**Re: Fuji Clean CEN 10 Traffic Bearing Design and Method**

The Suffolk County Department of Health Services, Division of Environmental Quality, Office of Ecology has received and reviewed the design drawings and installation methods prepared by FujiClean USA, LLC, with your signature and seal and dated 1/20/2023 for the "12' DIA PRECAST DRAINAGE RING WITH FUJI CLEAN CEN10 AND H-20 CAST IRON LIDS AND RINGS FOR SUFFOLK COUNTY INSTALLATIONS".

**12" DIA PRECAST DRAINAGE RING WITH FUJI CLEAN  
CEN10 AND H-20 CAST IRON LIDS AND RINGS FOR  
SUFFOLK COUNTY INSTALLATIONS**

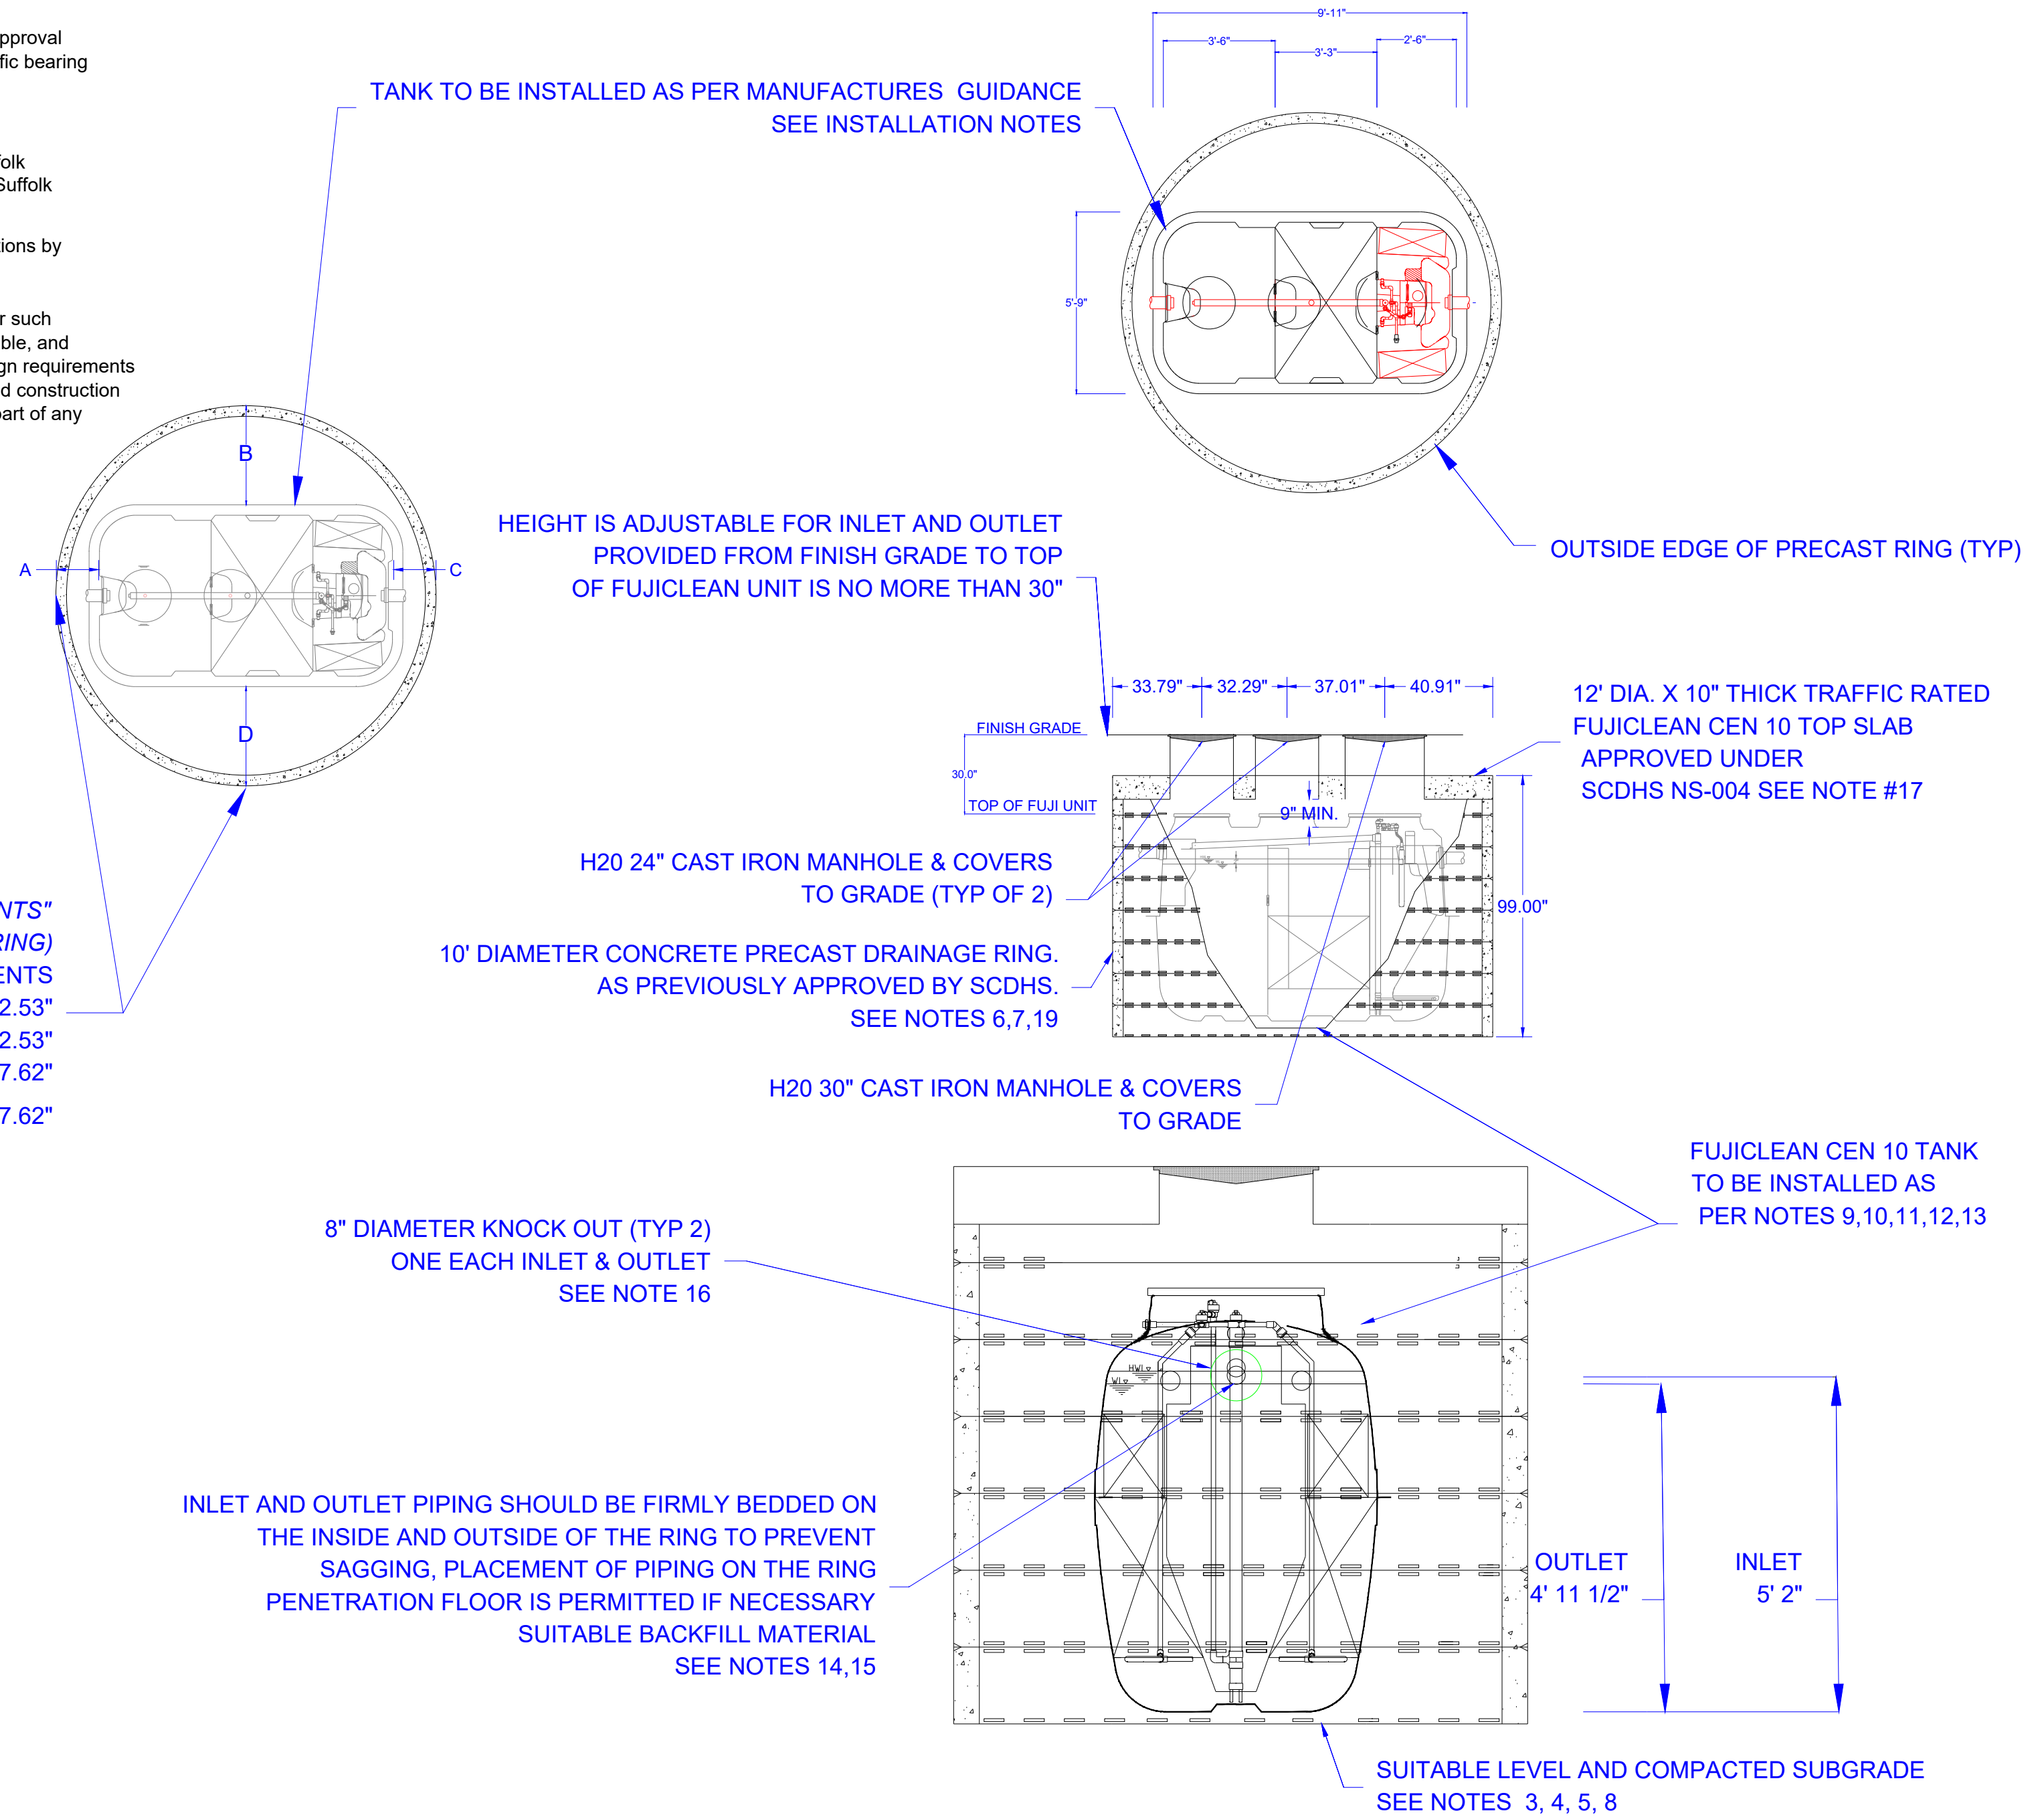
Based on the information provided, the Department of Health Services approves the use of this design as the means and methods for allowing the Fuji Clean model CEN 10 to be installed in traffic areas. A copy of this letter and the signed and sealed design will remain on file in the Office of Wastewater Management for future reference. Additionally, the approved design will be incorporated into the Fuji Clean Vendor Guidance Document, maintained by the Office of Ecology.

The Department has reviewed this submittal for completeness and is hereby approved for use in Suffolk County. This approval is solely for the model(s), units(s) and/or structure(s) included in the engineering design drawings and calculations provided by the licensed design professional. Any changes or modifications to the approved design must be submitted for review and approval by the Department prior to its use in Suffolk County. The Department is not responsible for any errors, omissions, failures, construction defects or installation errors that may occur due to design professional, manufacturer, distributor or installer oversight or negligence.
